| 1 | 19-21 Myra Avenue, Ryde - New multi dwelling housing development containing 5 dwellings (2 x 5 bed and 3 x 3 bed) as well as strata subdivision - LDA2020/0185 | 3 |

City of Ryde Local Planning Panel Report

DA Number	LDA2020/0185
Site Address & Ward	19-21 Myra Avenue, Ryde NSW 2112 Lot A Deposited Plan 408670 and Lot 11 Deposited Plan 12555 Central Ward
Zoning	R2 Low Density Residential
Proposal	New multi dwelling housing development containing 5 dwellings (2 x 5 bed and 3 x 3 bed) as well as strata subdivision.
Property Owners	Robert De Nicola and Patricia De Nicola
Applicant	Robert De Nicola and Patricia De Nicola
Report Author	Brendon Clendenning, Consultant Planner
Lodgement Date	29 May 2020
No. of Submissions	Seven (7) submissions and a petition during first notification. Four (4) submissions and a petition during second notification.
Cost of Works	\$2,476,320.00
Reason for Referral to LPP	Contentious development – (b) in any other case – is the subject of 10 or more unique submissions by way of objection. <i>Schedule 1, Part 2 of Local Planning Panels Direction</i>

Figure 11 Flood Risk Map – low (light blue) medium (dark blue)

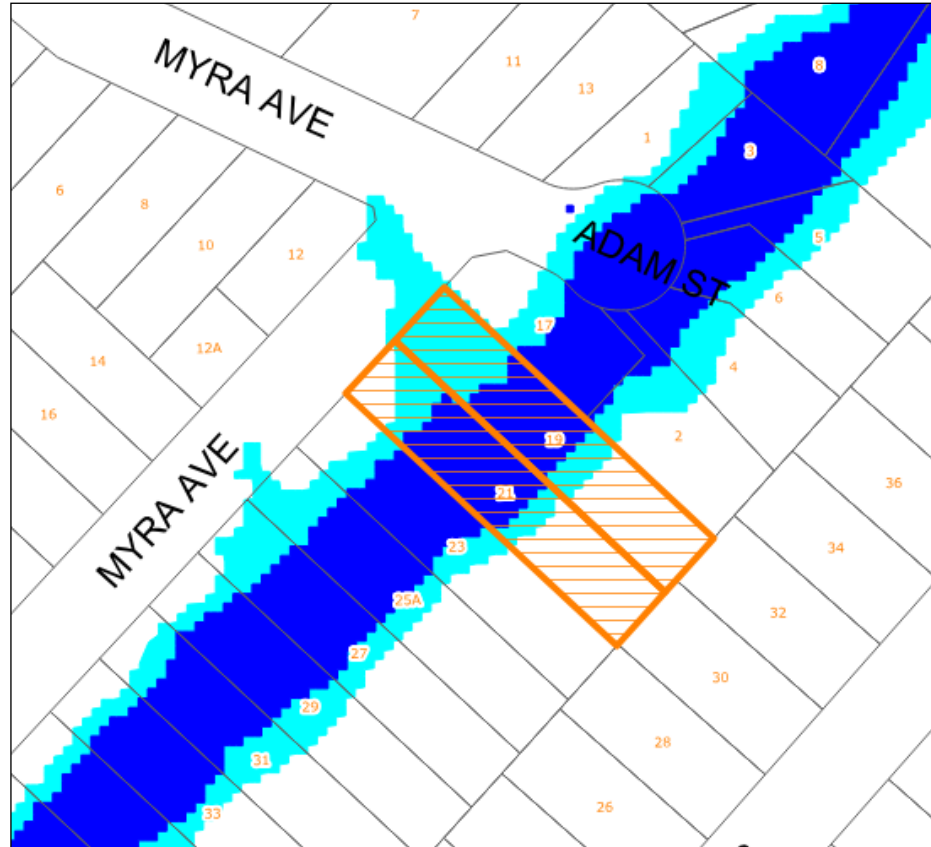
The site is identified as being a “Flood Planning Area” on the Flood Planning Map. The proposal has been supported by a Flood Impact Assessment Report Rev C prepared by StormCivil Pty Ltd. The objective of this clause is to minimise the flood risk to life and property, allow for development that is compatible with the flood hazard and to avoid significant adverse impacts on flood behaviour and the environment. The site is mapped as being impacted by Low to Medium Risk flooding over a large proportion of the front and middle of site as shown in **Figure 11**.

- The proposal has not been supported by satisfactory information.

Figure 12 Shadow diagrams on 21 June

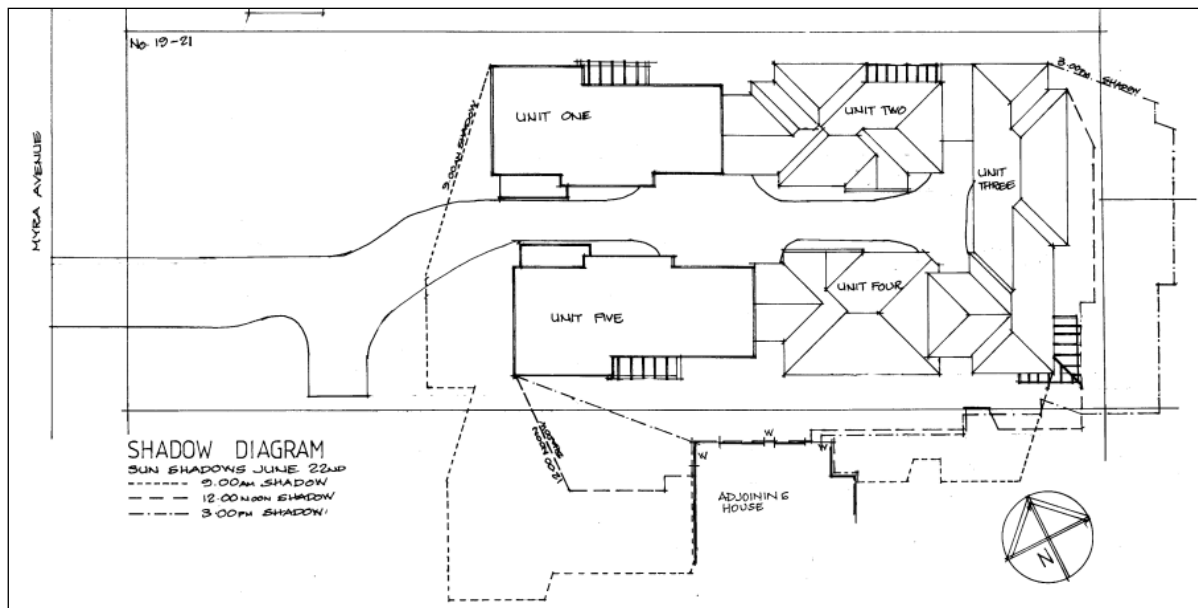
The proposal is non compliant with control (c) of Section 3.6 and control (b) of Section 3.9 in that 50% of the private open space does not receive the required solar access of 2 hours. For private open space on adjacent properties that are already non-compliant, sunlight must not be further reduced by more than 20%. The submitted shadow diagrams depict the 9am, 12pm and 3pm shadow impact in midwinter (**Figure 12**).

The submitted shadow diagrams indicate that the private open space of the southern oriented units, being Unit 4 and Unit 5, will each receive non-compliant solar access during midwinter. Unit 5 contains a western and northern elevation associated with the living room receives reasonable solar access and is acceptable despite the private open space not receiving compliant solar access.

The submitted shadow diagrams does not show the shadow cast from Unit 1 and 2 at 12 noon and 3pm and the impacts upon the proposed Units 3, 4 and 5, which are located to the south and south-east cannot be determined. It is considered likely, the living areas of Unit 4 and 3 will not receive the required solar access.
